## **DEVELOPMENT REVIEW COMMITTEE (DRC) COMMENT REPORT**

**Project Name:** FLL Land Holdings, LLC / Sistrunk Townhouses

**Case Number:** R15040

**Request:** Site Plan Level II Review: 24 Townhouse Units

A-7

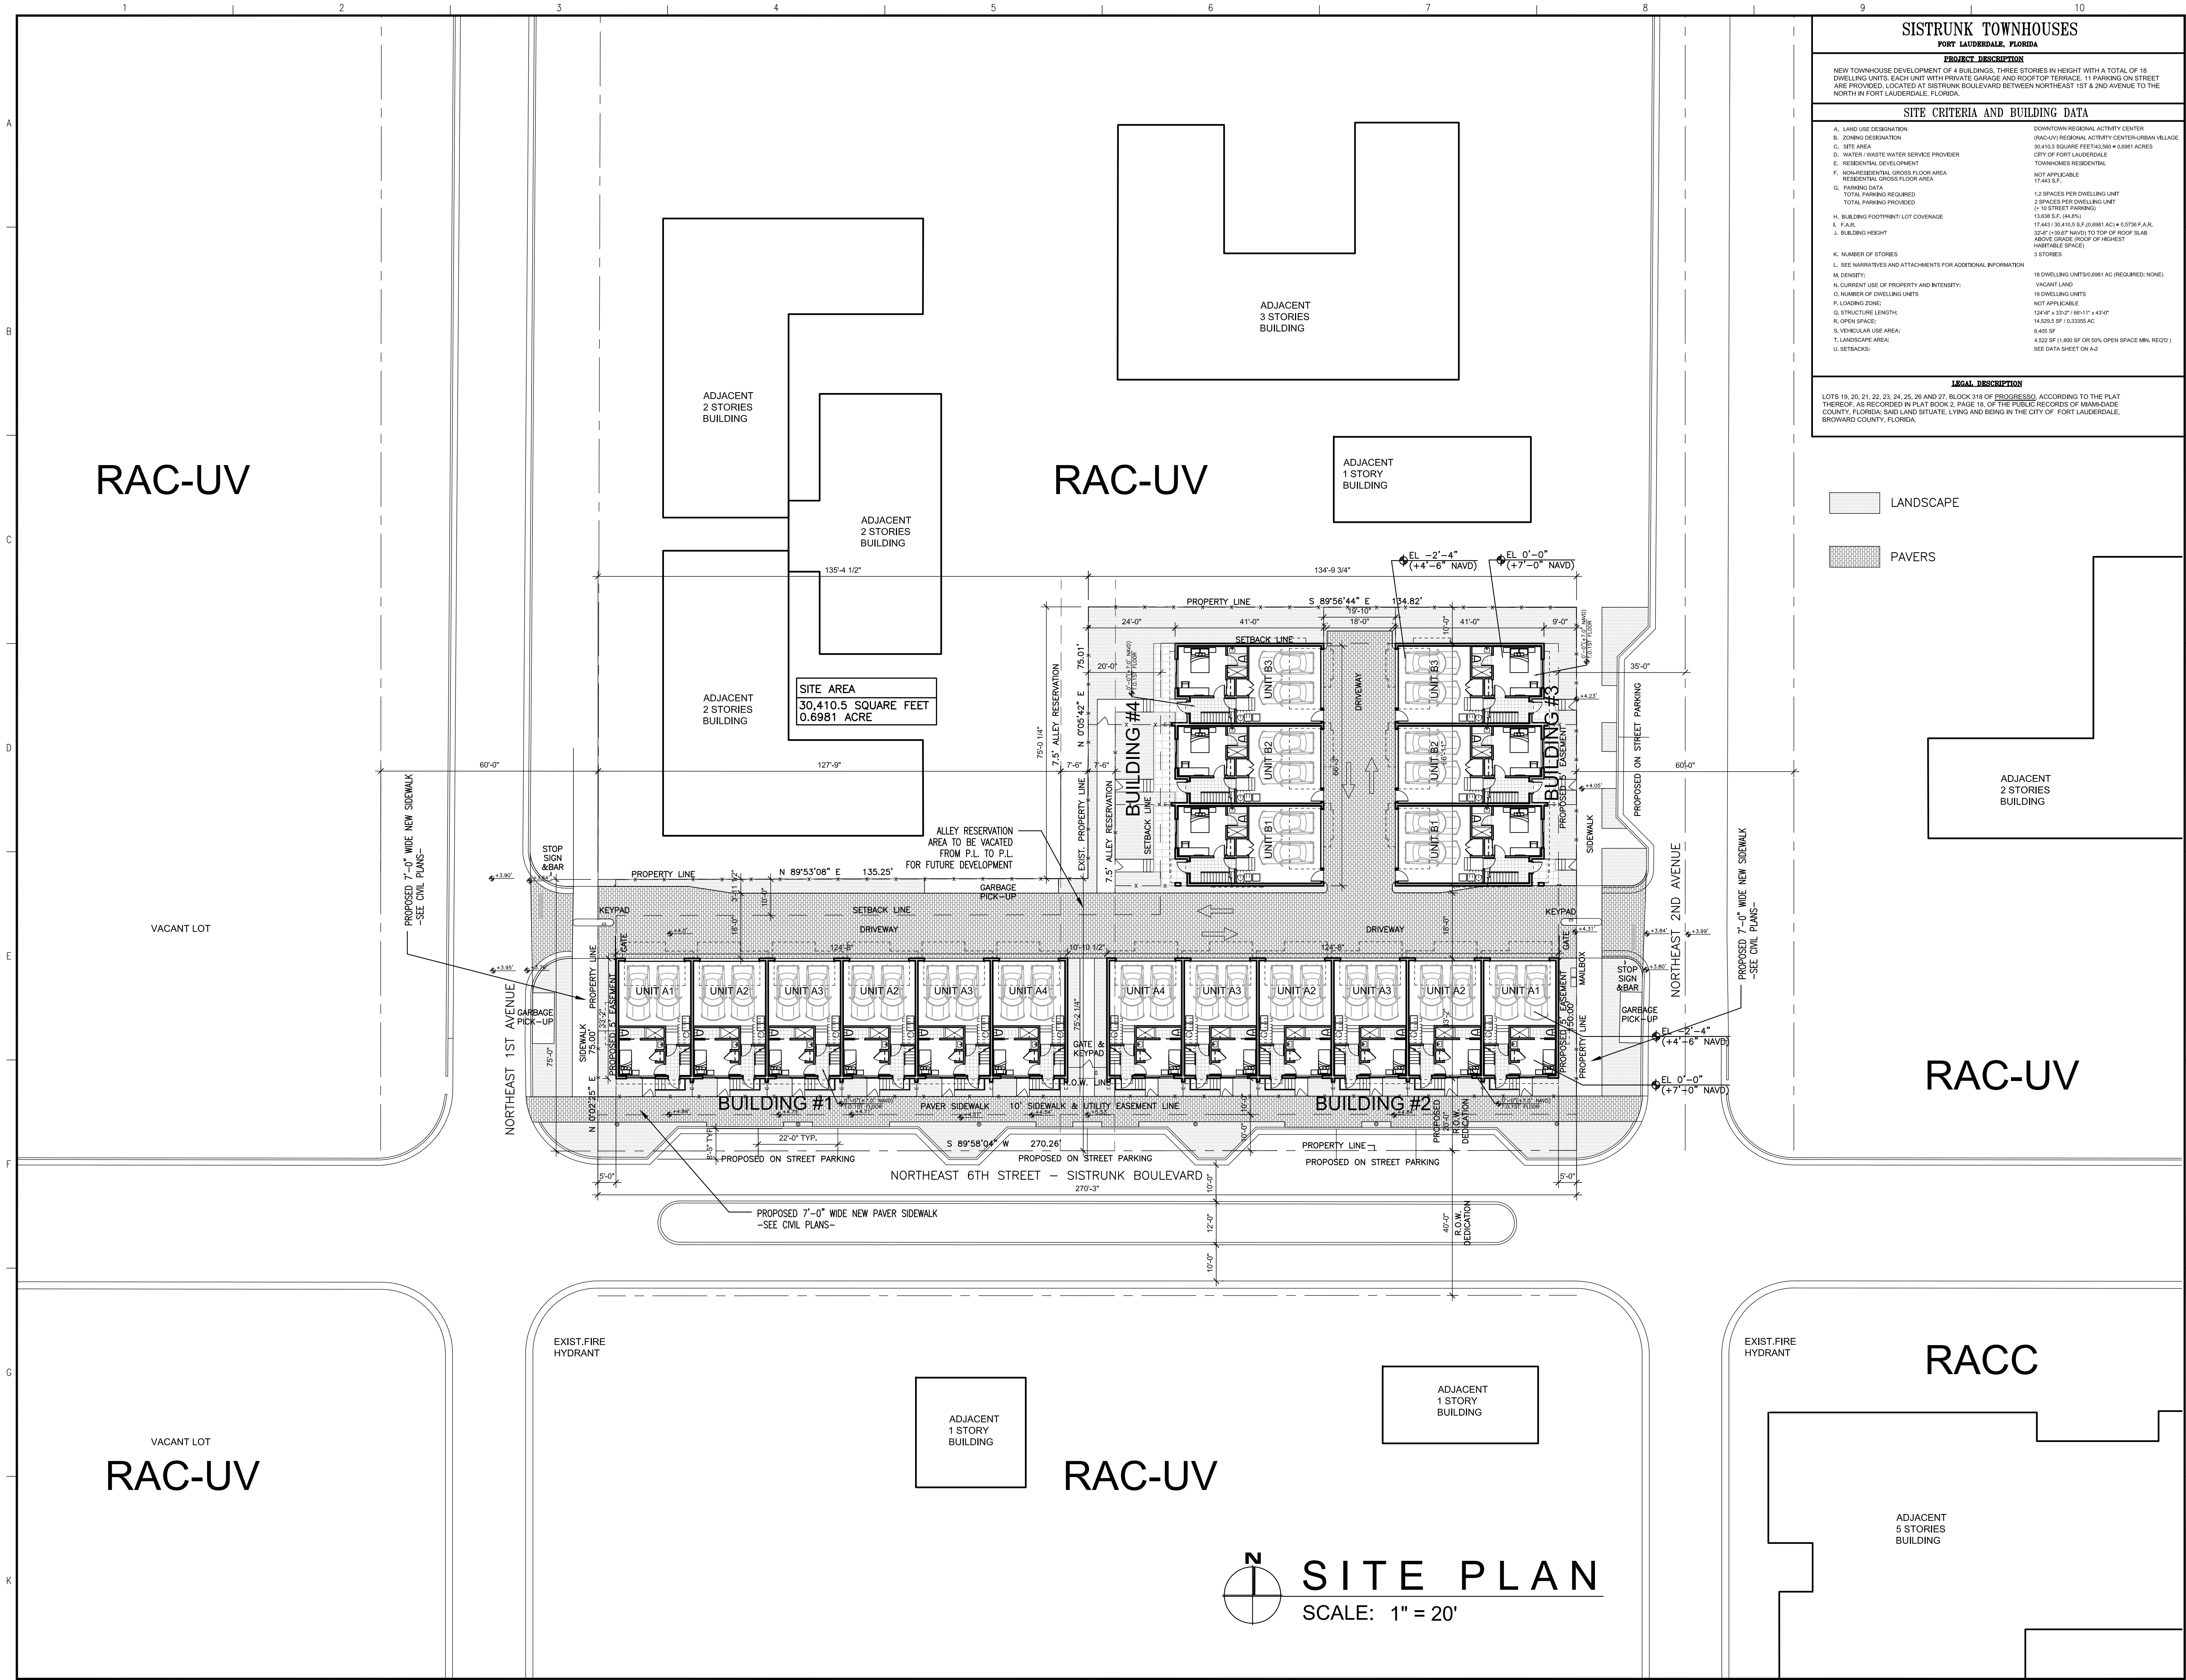
5. Show and callout delineations for proposed Right-of-Way (including corner chords) and permanent easement boundaries more prominently on the Site Plan and the Civil drawings.

6. Provide an aisle of 24' wide behind all 90-degree parking spaces in accordance with ULDR Section 47.20.11.A. Also review potential to provide narrower driveways at ingress/egress points to minimize pedestrian/vehicular conflicts, with flare outs internally on-site to meet requirements of Sec. 47-20.11.

14. Dimension typical roadway travel lane widths on the Site Plan for N.E. 1<sup>st</sup> Avenue, N.E. 6<sup>th</sup> Street / Sistrunk Boulevard, and N.E. 2<sup>nd</sup> Avenue.

16. Show and label sight triangles as appropriate (per ULDR Section 47-2.2.Q), for safe and adequate access of drivers and pedestrians, on the Site Plan, Landscape Plans, and Civil Plans as appropriate: intersections of driveways with streets (measured from pavement edges), alleys with alleys (measured from property lines extended), alleys with streets (measured from property lines extended), and streets with streets (measured from property lines extended).
